Project Name:	212 Seabreeze Avenue
Project Location:	212 Seabreeze Avenue
Request:	Certificate of Appropriateness (COA), Waiver, & Variances
Board:	Historic Preservation Board
Meeting Date:	May 1, 2019

STAFF REPORT

ITEM: 212 Seabreeze Avenue, Individually Listed to the Local Register of Historic Places – Certificate of Appropriateness (2018-191), Variances (2019-130) to reduce the front yard setback for a pool and to reduce the finished floor elevation for the new first floor addition, and Waiver (2019-131) to the Visual Compatibility Standards to allow the new addition to be constructed in a manner that is not secondary nor subordinate to the existing structure.

CV1.0

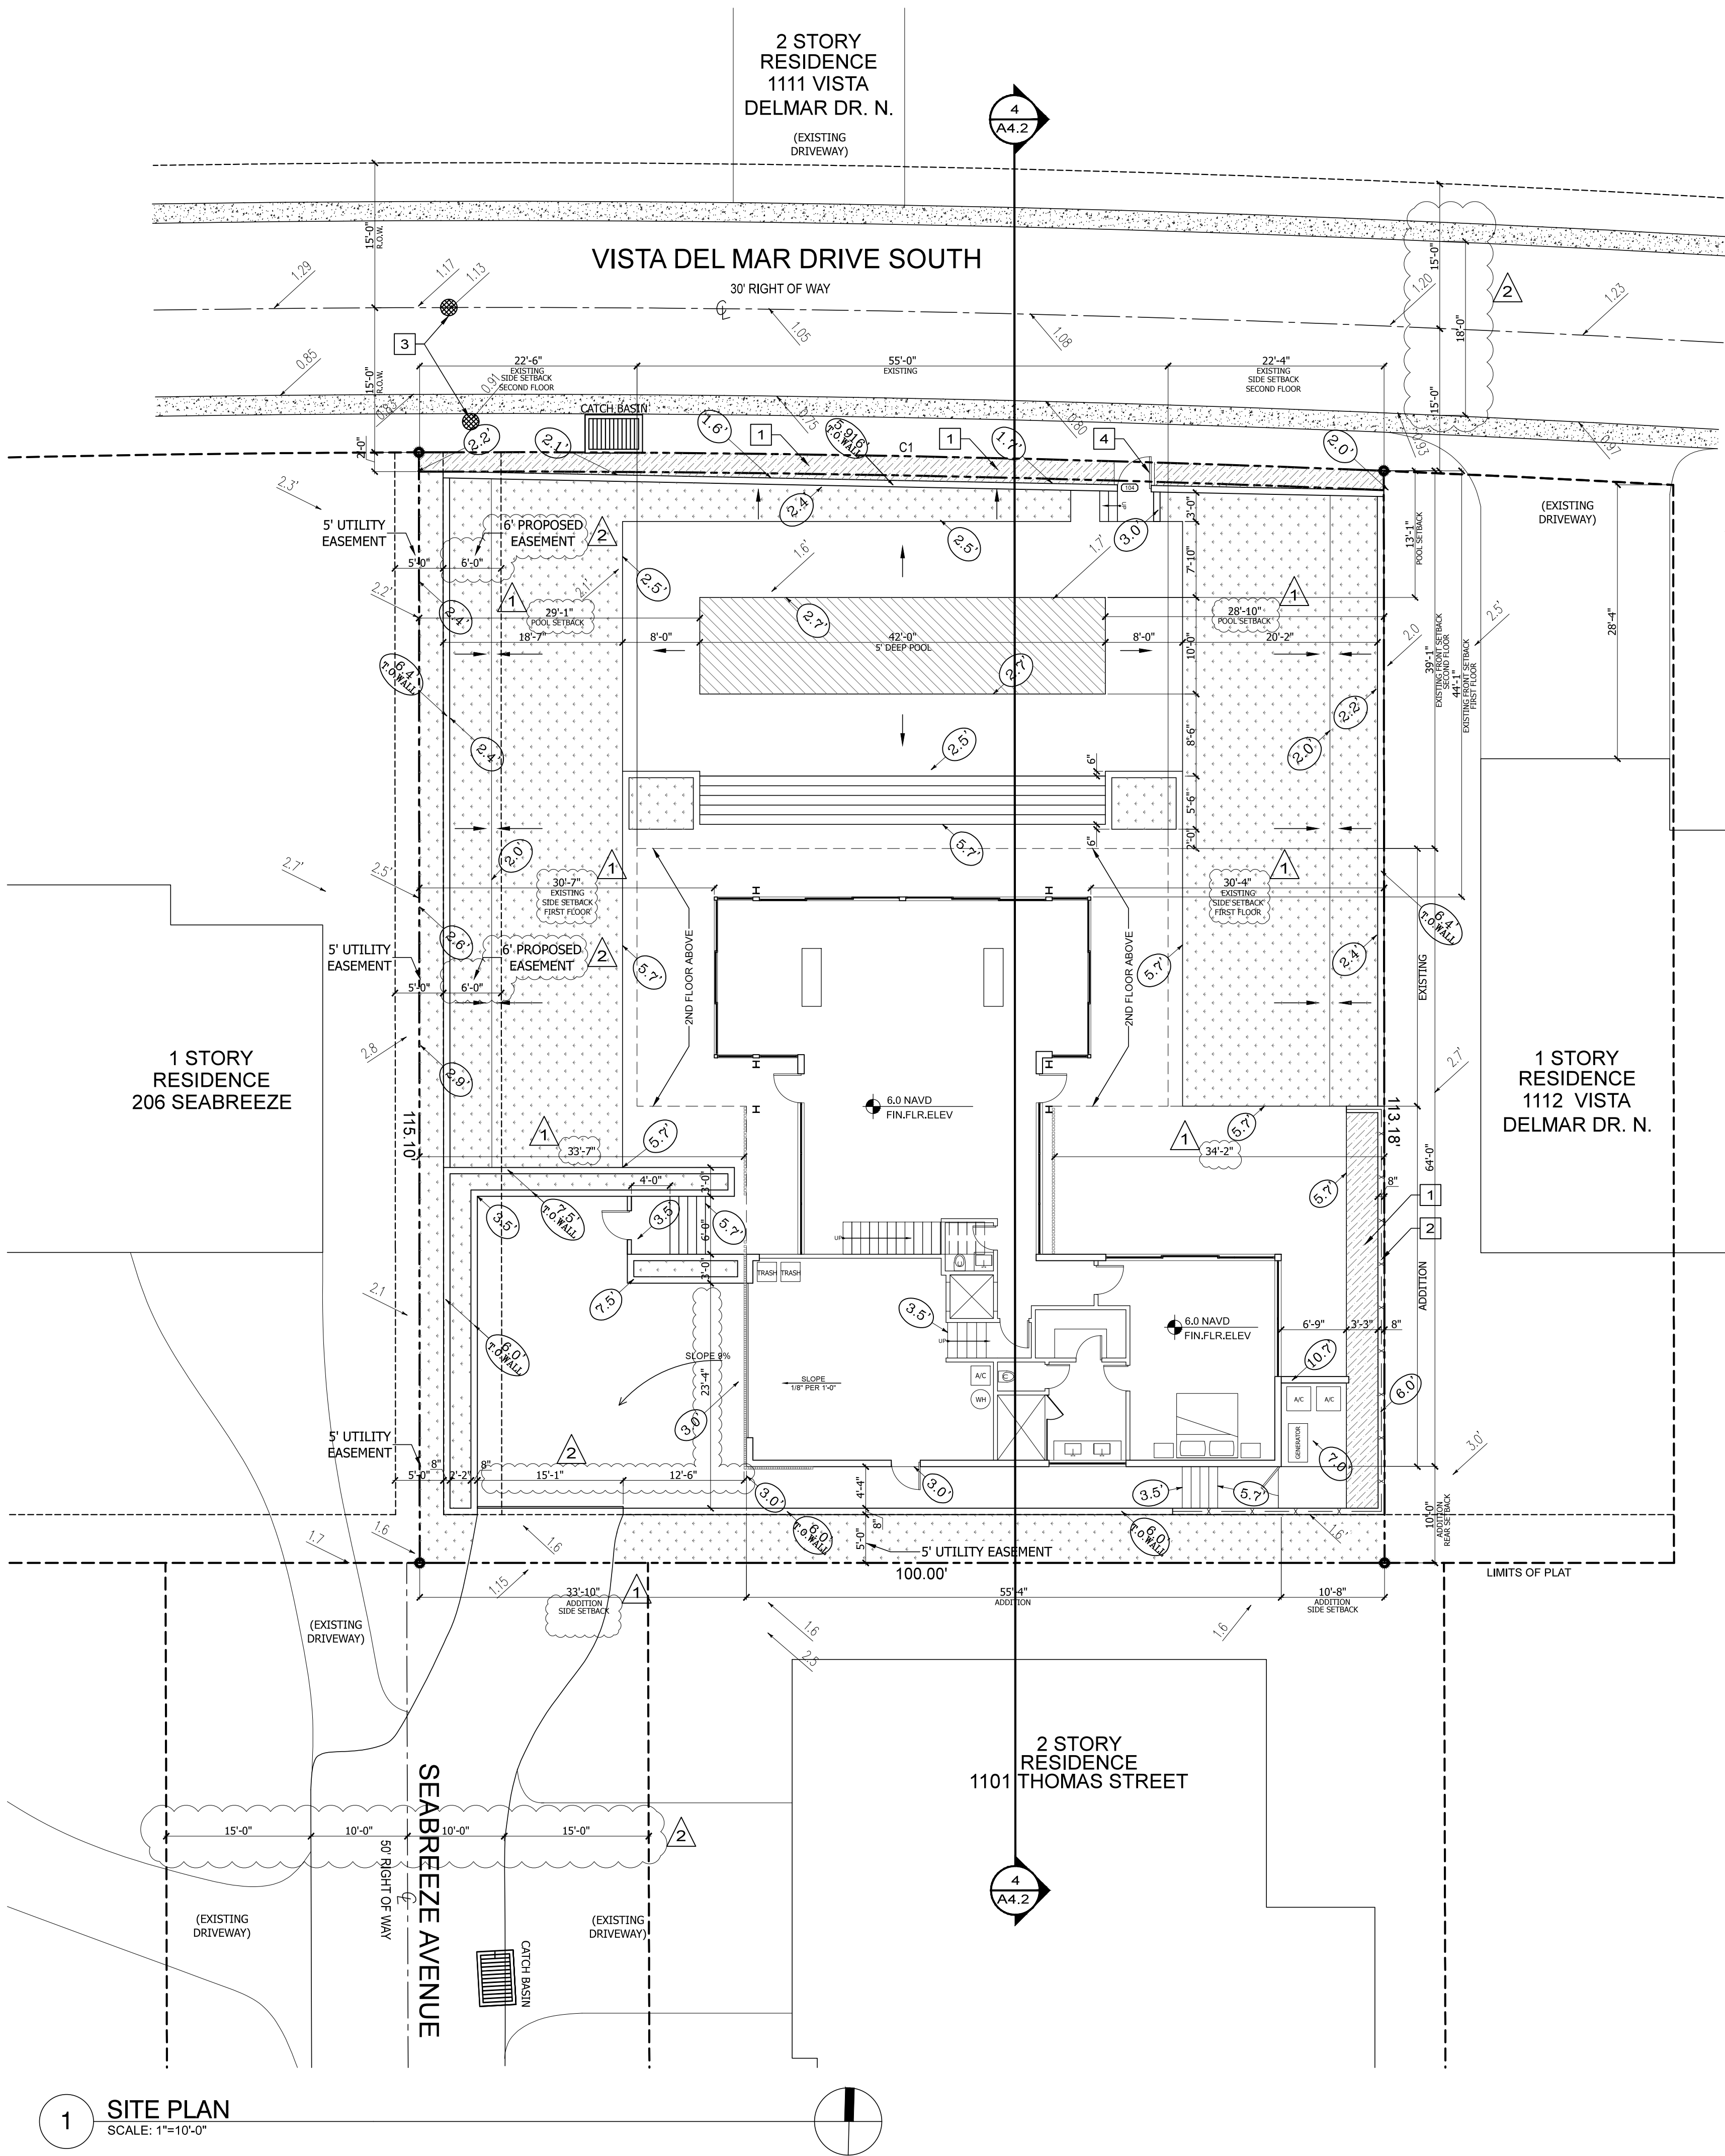
1. That the 2 new windows on the north elevation be removed; and,
2. That the site data table be corrected to reflect the existing and proposed 1st and 2nd floor square footage calculations for overall building area and air-conditioned building area.

8 NORTH ELEVATION - PROPOSED
SCALE: 1/8"=1'-0"

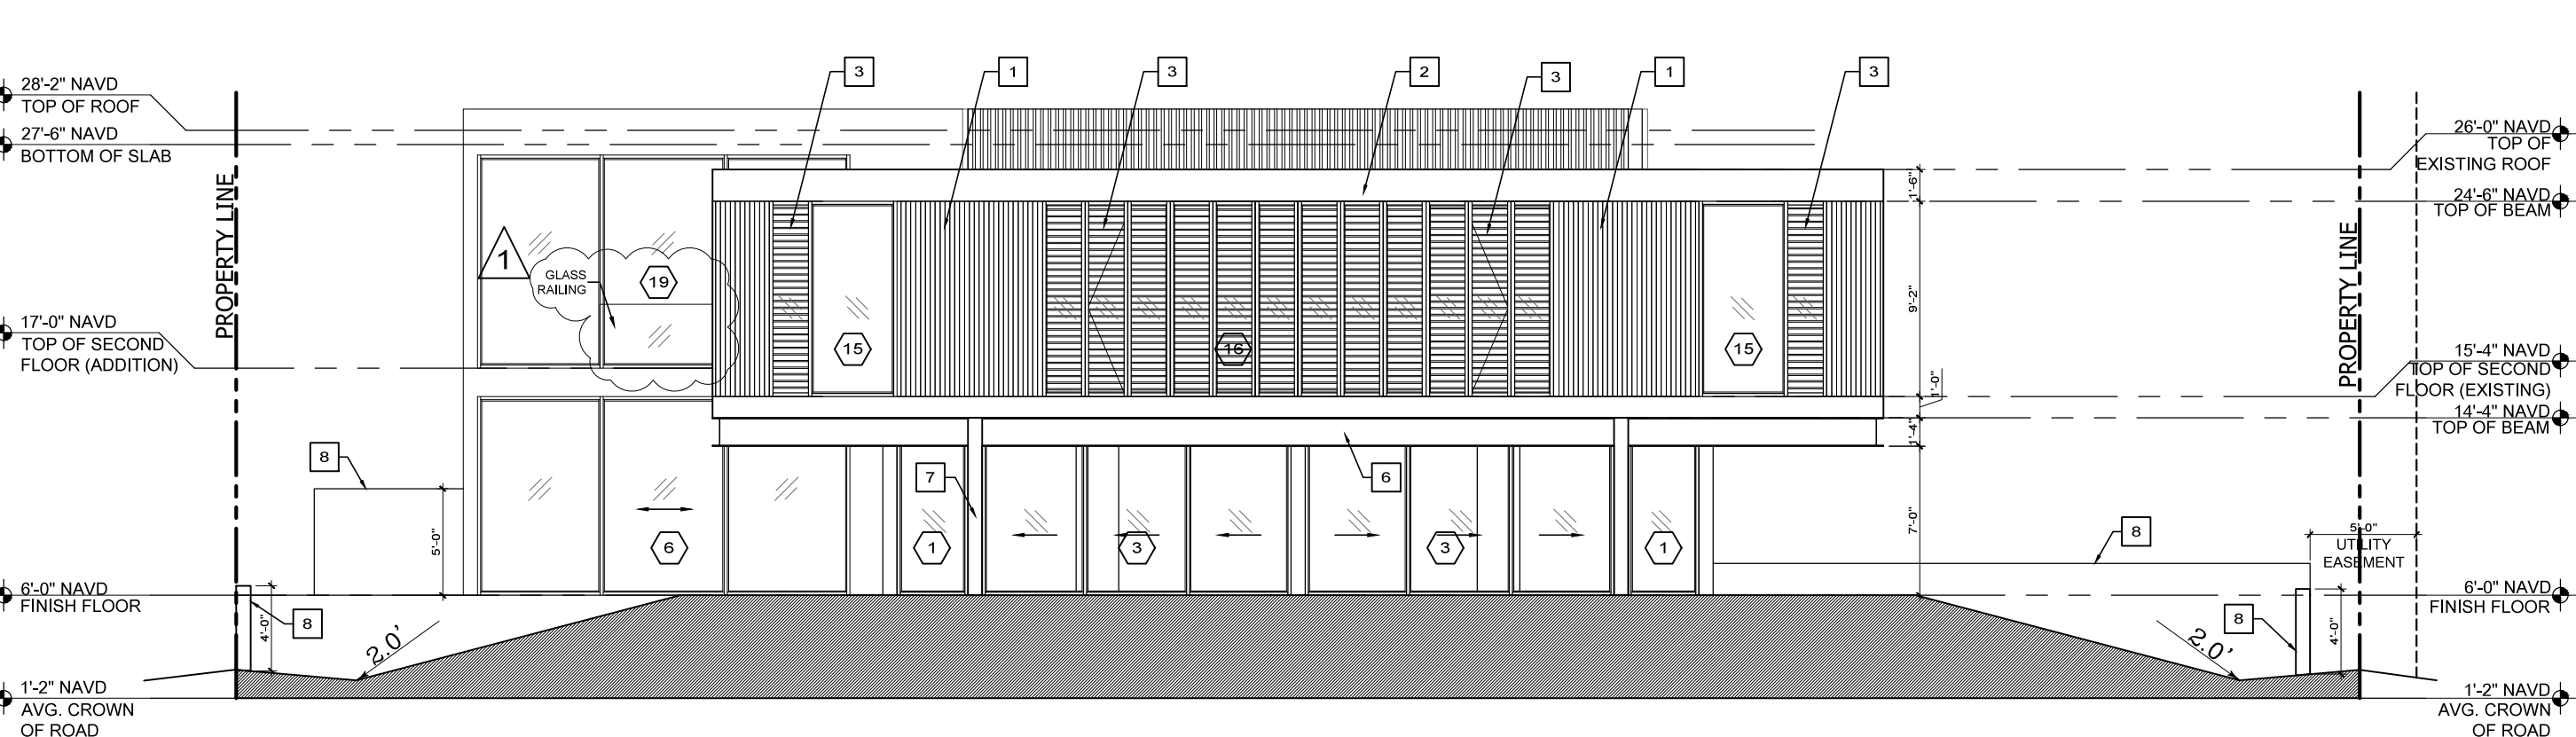
The proposal involves restoration of a portion of the original window opening and louvers on the north/front elevation facing South Vista Del Mar Drive. This opening was originally covered with louvers to allow for airflow as the structure did not originally have central air conditioning. Two new large windows are proposed on the north elevation and these windows were not original to the design of the structure; thus, they should be eliminated from the north elevation in an effort for true restoration preserving the historic integrity and character of the property (**Standards 2, 5 & 9**). This item has been attached as a condition of approval.
